Service Letter

| S.L. Number: | ZE-2009-05 | | | | | | | | | | | | | | | | | | | | |
|----------------------------|---|-----------|--|-------------|-------------|------|----------------------------|-------------|---|--------------------|-------------|---|------------------------|-------------|---|------------------|--|-----------|--|--|--|
| Date of issue: | November 24, 2009 | | | | | | | | | | | | | | | | | | | | |
| Subject: | Aileron Bell-Crank stiffeners for the CH 601 XL/CH 650E. | | | | | | | | | | | | | | | | | | | | |
| Affected Models: | All CH 601XL/CH 650E models built and operated as ULM (MTOM of 450 kg + 5%) as defined by LTF-UL standards (or similar). | | | | | | | | | | | | | | | | | | | | |
| Serial Number(s) | All affected models | | | | | | | | | | | | | | | | | | | | |
| Manufactured by: | Czech Aircraft Works (CZAW) and others. | | | | | | | | | | | | | | | | | | | | |
| Purpose: | According to the <u>Institute for Reliability Engineering</u> at the <i>Technical University of Hamburg, Germany</i> , this modification has the potential to further reduce the possibility of non-linear vibrations in the aileron control system of the affected aircraft. | | | | | | |

TOP SIDE OF RIGHT WING

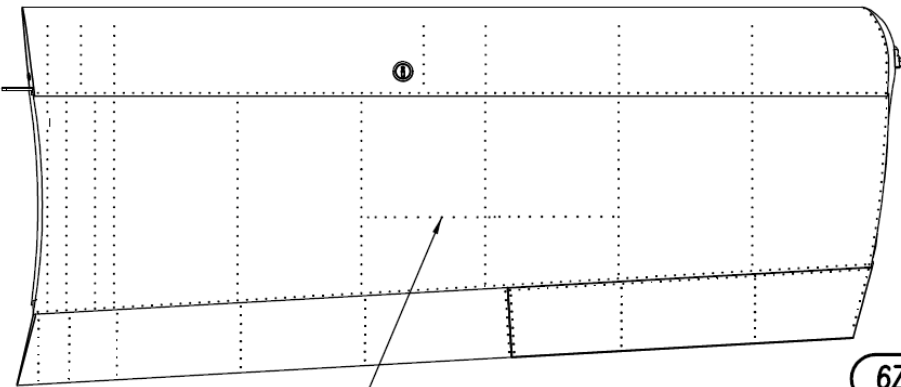
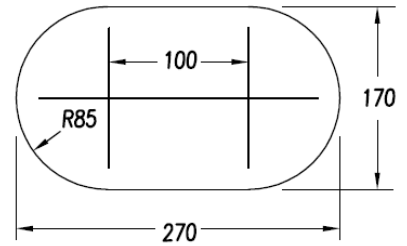
6Z-1G-2 ANGLES
OUTBOARD OF RR #7
TOP AND BOTTOM
A4 PITCH 50

6Z-1G-1 **BELLCRANK SUPPORT CHANNEL**
t=.040" 6061-T6 (2 REQ'D)

6Z-1G-1
REPLACES 6W6-10 BY 6Z-1G-1
ADD 2 RIVETS A5 IN ENDS
OF 6Z-1G-2 ANGLES

6Z-1G-2 **STANDARD L ANGLE**
t=.025" 6061-T6 (4 REQ'D)
TRIM TO FIT

6Z-1G-2 ANGLE IN LINE WITH
FRONT FLANGE OF BELLCRANK
SUPPORT CHANNEL 6Z-1G-1
TOP AND BOTTOM

BOTTOM SIDE OF RIGHT WING

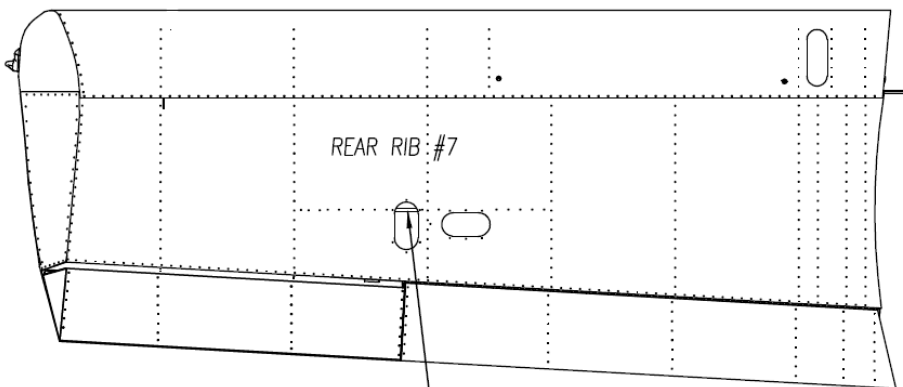
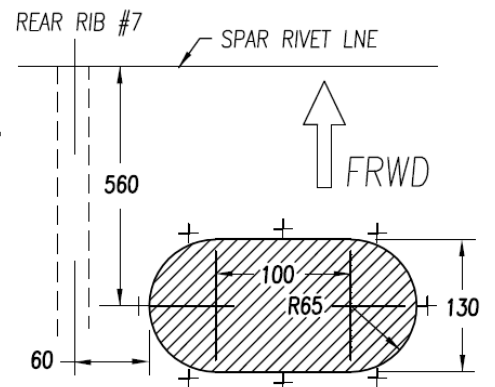
6Z-1G-3 **AILERON ACCESS COVER**
t=.025" 6061-T6 (4 REQ'D)
OVERLAPS ON OUTSIDE

AILERON ACCESS COVER IS
REPLACED TO OVERLAP ON
OUTSIDE WITH NUTPLATES
OR RIV-NUTS ON BOTTOM SKIN

CUTOUT IN BOTTOM SKIN 6W8-2
TO REPLACE CHANNEL WITH 6Z-1G-1
AND TO ADD STANDARD L ANGLES.
NOTE: HOLE NOTE REQUIRED IF REAR TOP
IS REMOVED TO DO MODIFICATION.
